Westway – a cycling assessment

Work on changes to the Westway started in 2016 and have continued into 2017. They have principally involved alterations to the bus lanes, but also include measures to make the area attractive and more pedestrian friendly.

Wheelrights were concerned about an apparent lack of provision for cyclists. Accordingly their *Routes Group* made a detailed inspection of the area on 4 February 2017. This report contains our findings. Recommendations are made on how to make it more cycle friendly.

Looking N. from Paxton St.

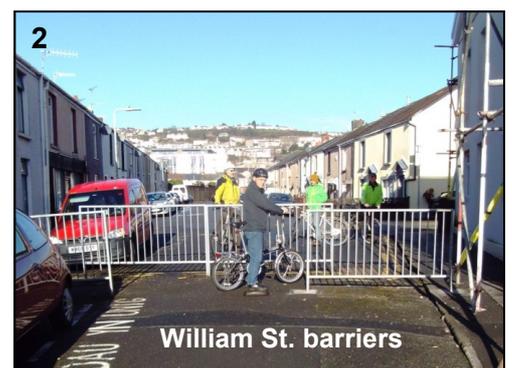
This is an existing cycle route. Photo 1 shows where it crosses Glamorgan St. - Clarence Terrace and photo 2 the barrier immediately to the north of this.

A hazard for cyclist is that Glamorgan St. - Clarence Ter. is a 'rat run' and has priority. The barrier to the north is not particularly cycle friendly.

1. Remove the Glamorgan St. - Clarence Ter. priority.
One way of achieving this would be to provide broken lines (like those in Photo 1) on both sides of this junction so that neither direction has priority.
2. Replace the William St. barrier by bollards.

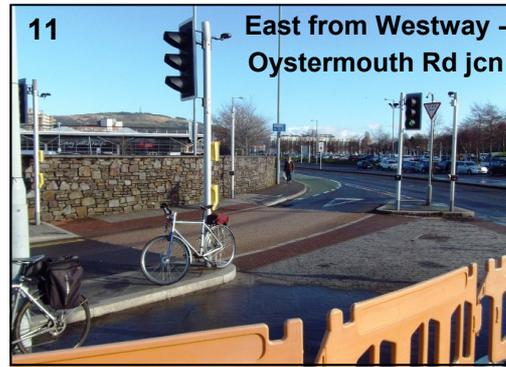
Photo 10 (overleaf) shows construction work underway at the time of the visit. The bus lane was then in use by southbound buses. We note that since then the footway has been widened to provide a shared use path which continues round the bend shown in Photo 10 to the Toucan crossing of Oystermouth Road (Photo 11). At the time of writing the work here was still in progress, but the provision appears to be what is needed.
